Will timeout work?

Karl Weber, Beckhoff Automation

Delay Variation cause Timeout

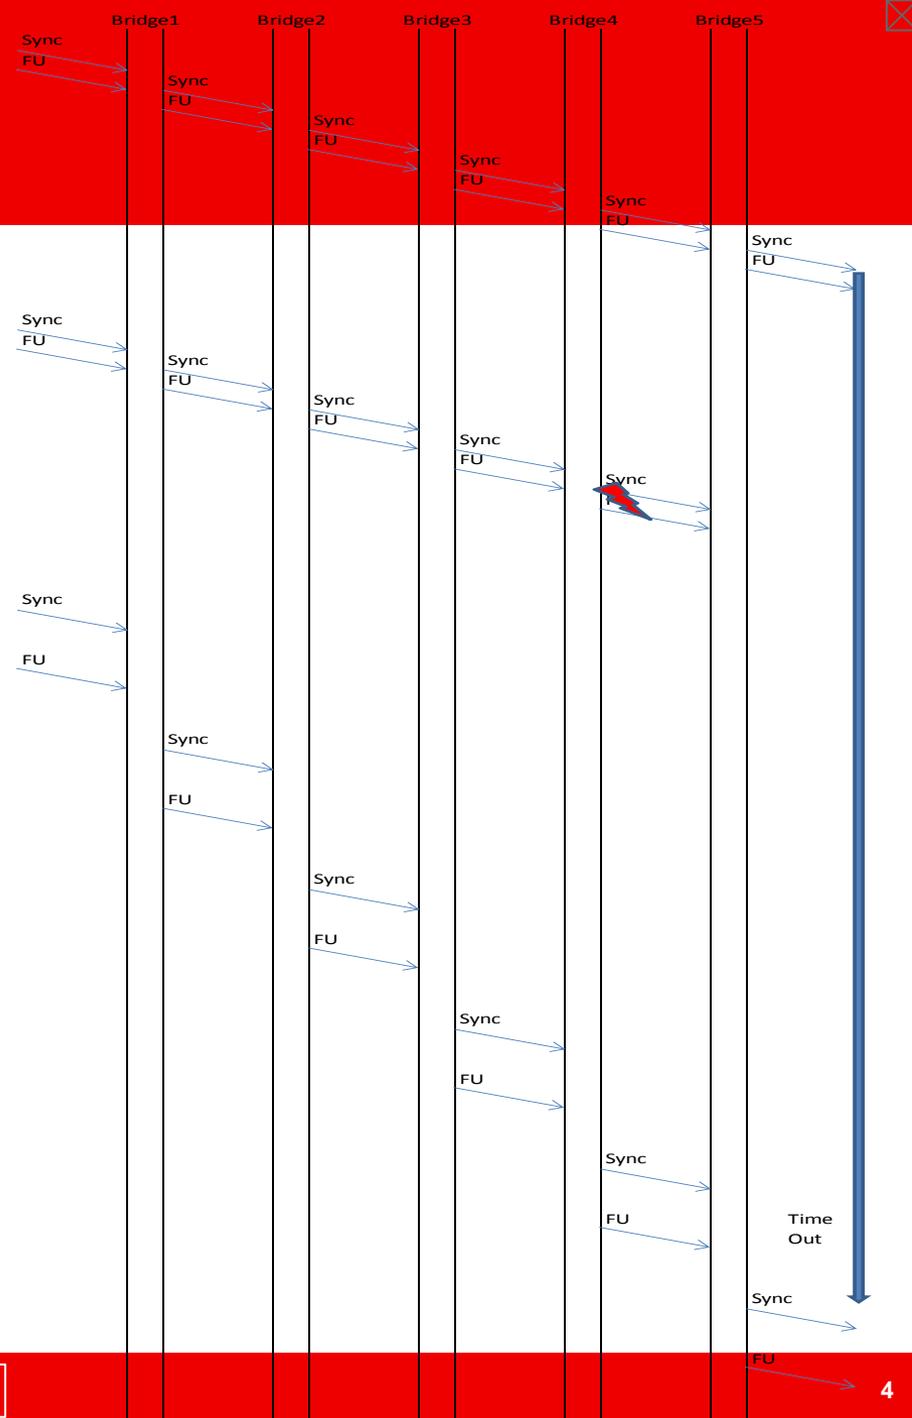
Situation

- Delay occurs in third sync
- Second Sync lost
- Delay:
 - Sync → FU: 1/15ms
 - FU → Sync: 1/15ms
- 5 bridges cause add delays:
 $5 * 28 = 140\text{ms}$
→ more than one cycle

→ We need a flexible timeout:
= 3 Periods

+NumberHops*ResidenceVariation
